Service Information

File In/With:	SI0372	
	New	1217
Equipment Affected:	YLAA	
Low suction faults: Electronic Expansion Valve Control Board

FIGURE 1 - CONTROL PANEL

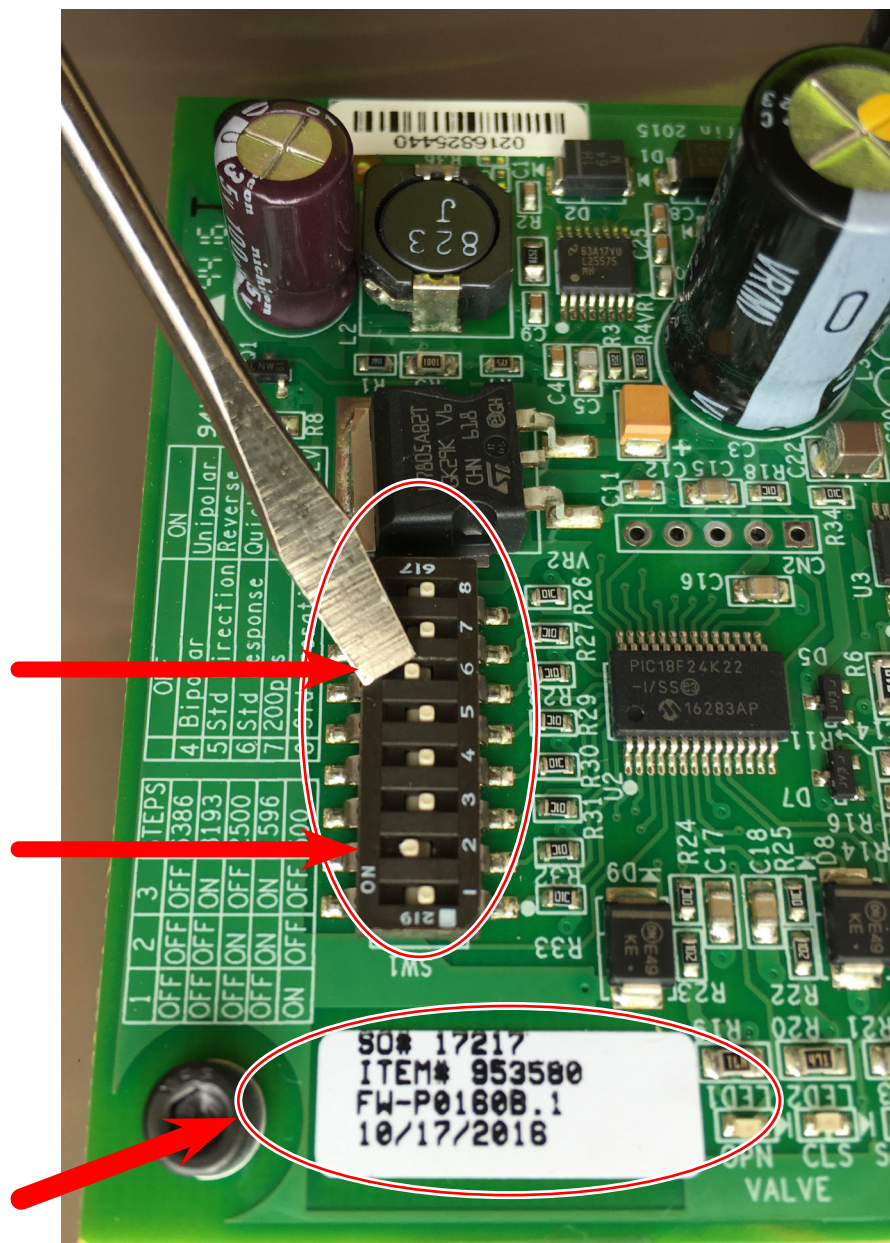
To identify if the chiller is installed with the firmware 'B' control board, look for the last alpha-numerical designation printed on the board (it should to be 'B'). As shown in *Figure 1 on page 2*.

If the chiller has the firmware ‘A’ board and is experiencing low suction faults, it may be necessary to switch the control board to the latest firmware ‘B’ to stop this nuisance fault.

1. Verify the software version on chiller by pressing HISTORY and then the DOWN ARROW to check. The software version should be **C.MMC.16.13**. If it is a lower version of software, it should be upgraded to the latest released version; 16.13, or newer.
2. Verify the firmware version on the EEV control boards (see picture). The firmware version should be “P0160**B**” in order to perform the next steps. If not as designated (Pxxxx**B**); procure part # 025-45462-042.
3. Remove all power from the chiller. There should be no lights on the EEV board.
4. Change DIP switch 6 to the ON position. **NOTE:** Do not change any other DIP switches. Only DIP switches 2 and 6 should be ON. See *Figure 1 on page 2*.
5. Reapply power to the unit and wait for the valves to complete the reset process.
